Landscape & Visual Impact Assessment Addendum

Land at Carpenders Park, Watford.

Date: 12/12/2025 | Pegasus Ref: P24-2420

P24-2420_EN_15-01

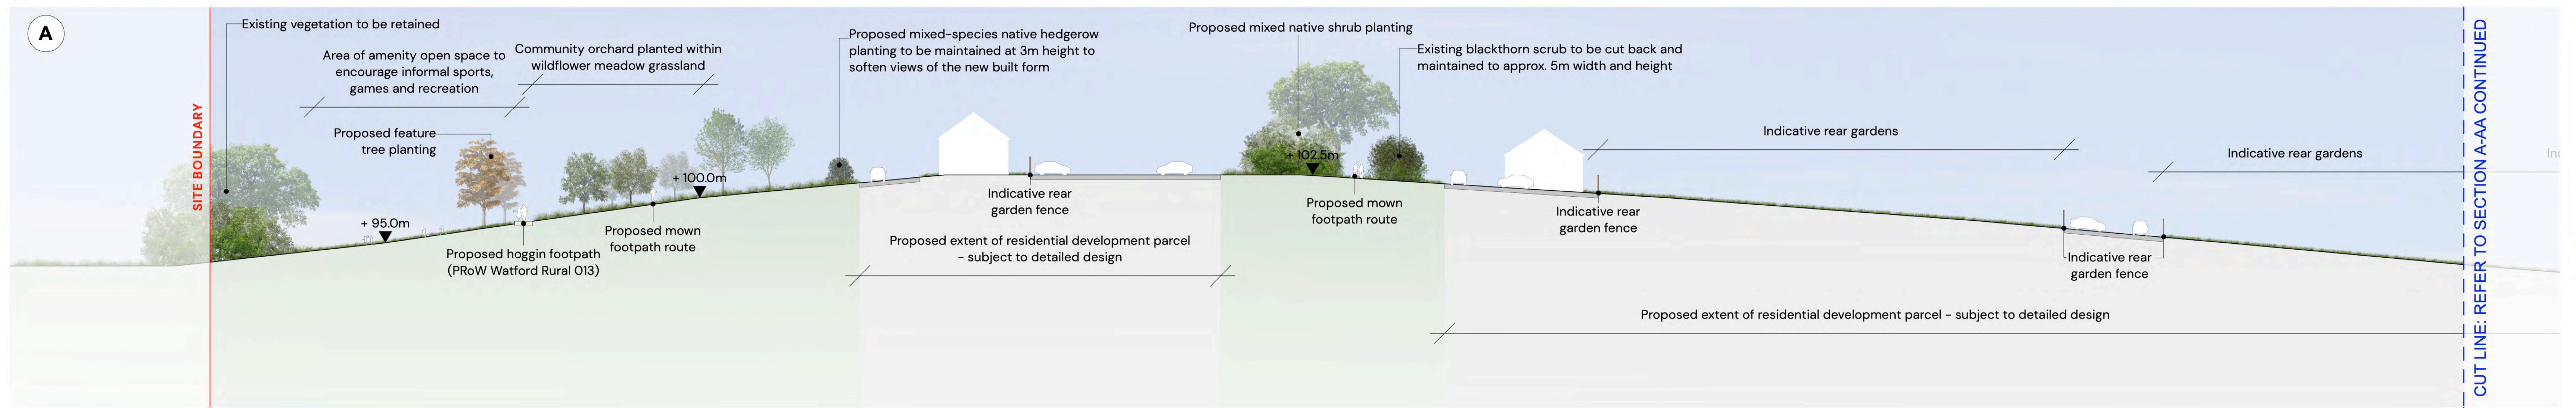
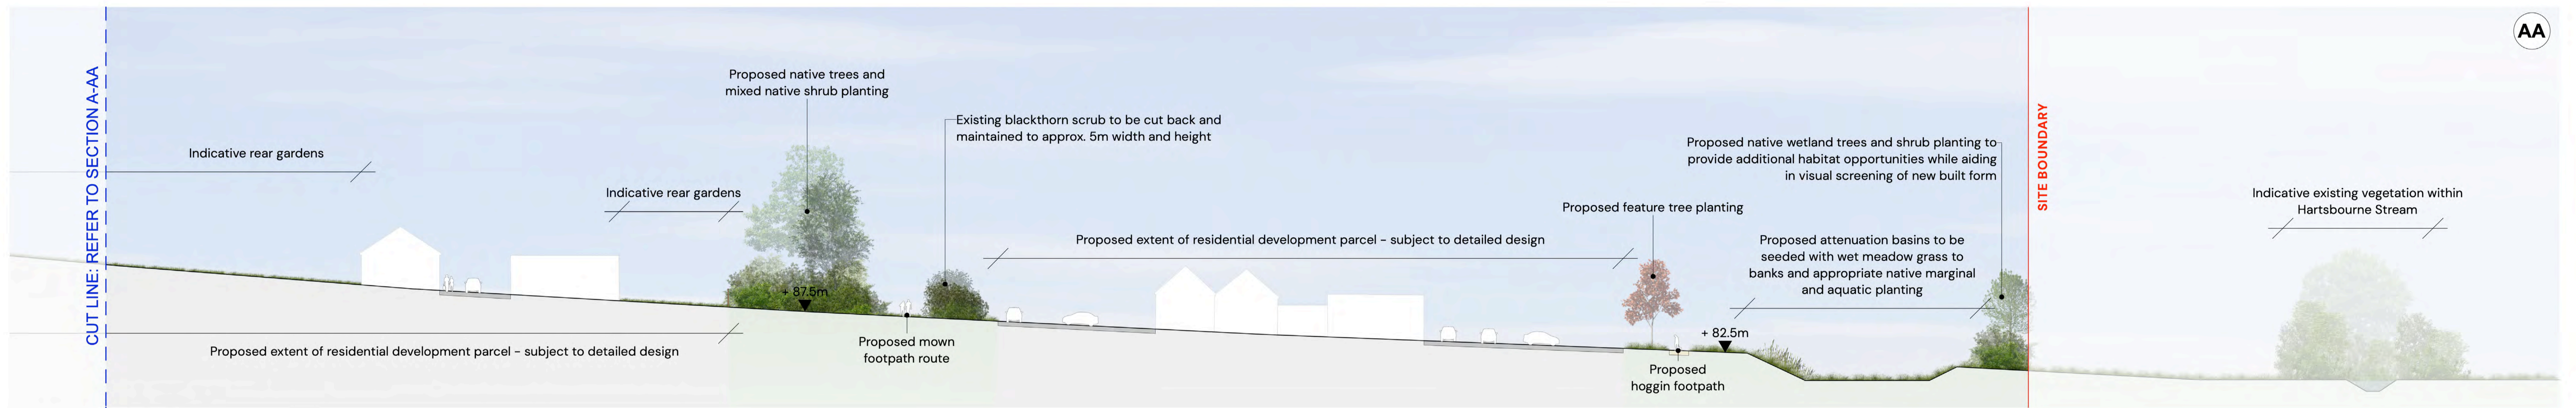
“While the LVIA states that changes to the landform will be minor, the proposal lacks sufficient supporting detail. No existing or proposed contour plans or cross-sections have been provided to illustrate the impact of the new access track, residential development, and attenuation area across the steepest slopes.

In reality, the residential development will be situated on sloping ground, requiring cut and fill operations and regrading to accommodate roads, driveways, and private gardens with usable gradients. We consider the site’s topography to be of high sensitivity, and the magnitude of change to be medium, resulting in a major adverse significance of effect. Therefore, we do not agree with the LVIA’s conclusion that the overall effect on topography would be minor adverse.”

- 3.6. To aid in understanding the level of effect arising from the Proposed Development upon the Site’s topography 2 No. Illustrative Landscape Sections have been prepared (see Appendix 2).

- 3.7. Having reviewed this additional information it is noted that a sympathetic design response could be delivered meaning that the overall gradients across the Site would still be legible with only localised changes to the landform proposed to facilitate construction of the SUDs basins, the road network, paths, parking areas and driveways, and with the digging of the new building foundations. Wholesale cut and fill operations to deliver level development plateaus would thus not be required to deliver the Proposed Development.

- 3.8. Once the construction of the proposed development is completed, the overarching pattern of topography of the Site would be maintained with landform largely retained at existing levels within the areas of public open space. The proposed residential parcels would avoid the steepest gradient land within the north-western corner of the Site, with the proposed vehicular access designed to follow a gentler gradient across the contours within the northern parcel of the Site. The magnitude of change to the overall ground profile of the Site would be medium where the topography is more challenging. With a medium sensitivity and a medium magnitude of change, the effect upon topography would be Moderate adverse at worst where noticeable level changes are anticipated. In other undeveloped areas of the Site levels will remain unchanged.

Fig 1.3: Chart of girth in relation to age and developmental classification of trees*

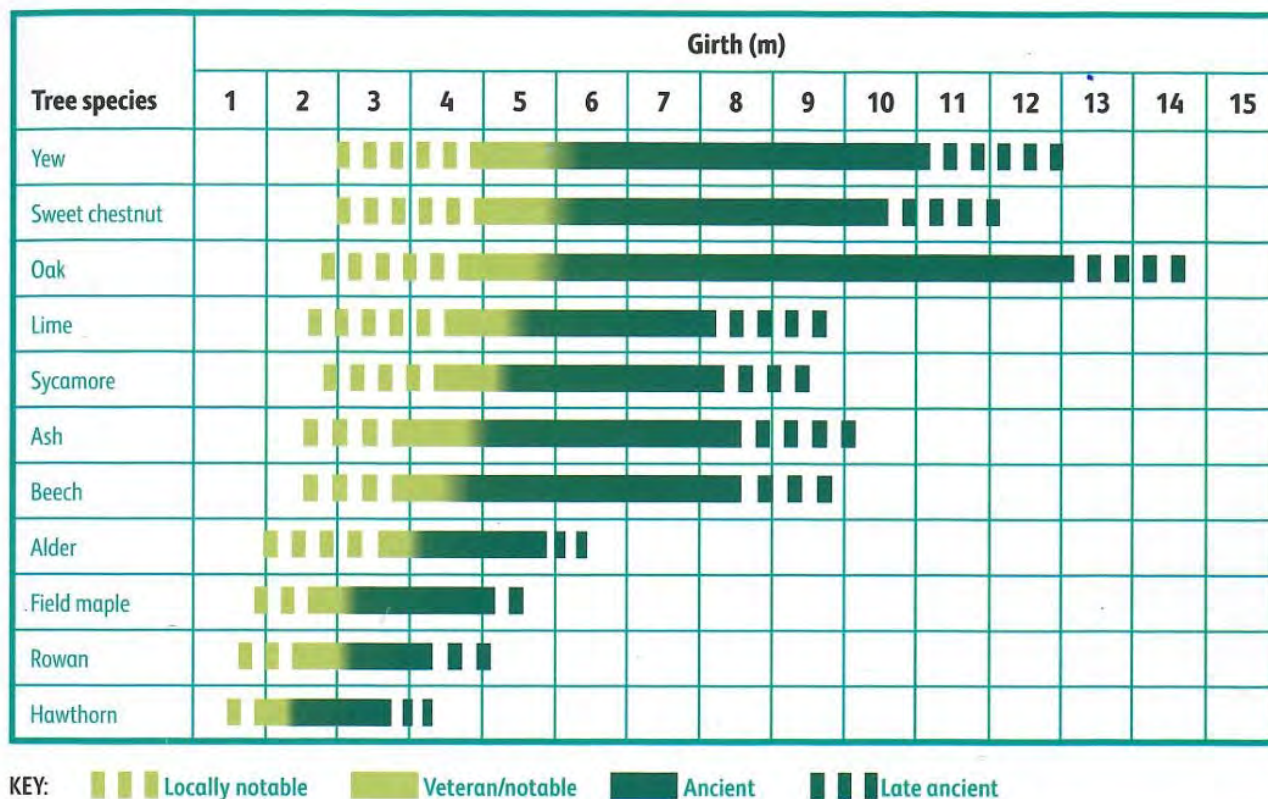
“...the Site contains several feature trees, including veterans, and retains historic landscape structure through its hedgerows. While the Site may not be designated as a ‘valued landscape’ under the National Planning Policy Framework (NPPF), it clearly contains elements of value. It reflects the character of the Bushey Hill Pastures LCA and functions as a transitional space between Carpenders Park and Merry Hill. We strongly disagree with the LVIA’s assertion that the Site represents an unremarkable settlement edge. The northern part of the Site, in particular, exhibits high sensitivity due to its topography, views, perceptual quality, recreational use, and transitional function, and should be protected from development and enhanced through appropriate management.”

3.16. As noted above the ACD Environmental response confirms that the trees within the Site are not defined or considered Veterans. The response notes further that:

“In reviewing the WT Ancient Tree Inventory there are no recorded Veteran/Ancient trees on the site.

Furthermore, using the standing advice in the WT publication Ancient and Other Veteran Trees: Further Guidance on Management, Section 1.2 Definition of Ancient and Veteran Trees. Figure 1.3 Chart of Girth in relation to age and developmental classification of trees captures classification based on girth. The table is provided below for reference.
